**2021/1127 (Planning)**  
**2021/1361 (Listed Building Consent)**

Demolition of walling, erection of rear two storey extension, installation of velux roof windows, erection of garage block, erection of stone boundary walls, amendment to vehicular access and installation of gates

Bank House Farm, High Street, Silkstone, Barnsley, S75 4FZ

**plans as proposed  
site plan**

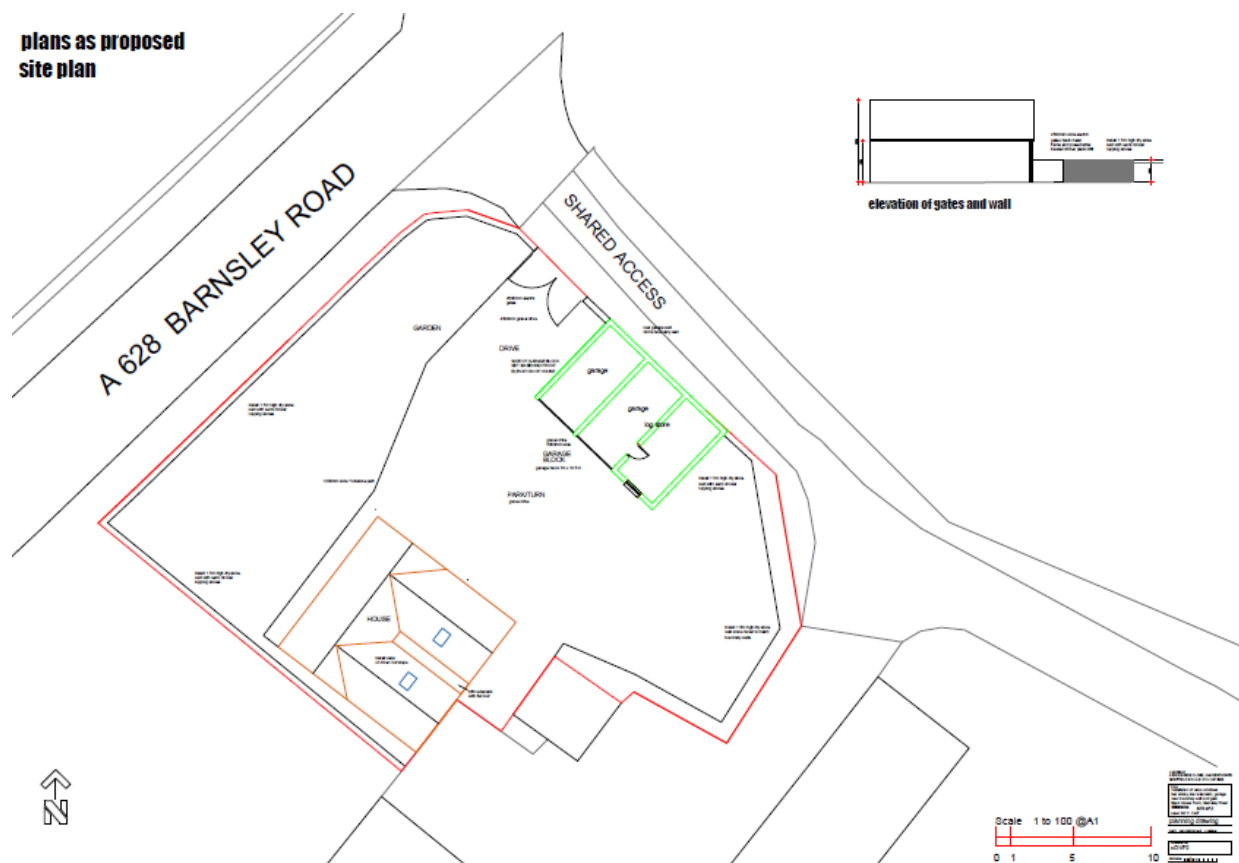
Consequently, I would request the garage block is re-positioned further to the south east to further reduce its prominence and avoid undue competition (visually) with the listed building. Assuming that is achievable I would raise no objections but would suggest rigorous conditioning of an approval to ensure materials and methods are appropriate and sympathetic.'

The plans have been amended and the garage block has been repositioned in line with the Conservation Officers comments. Overall, the proposal is acceptable and would preserve the character of the Listed Building and is in compliance with Local Plan Policies, D1, HE1 and HE3 and is therefore considered acceptable subject to conditions.
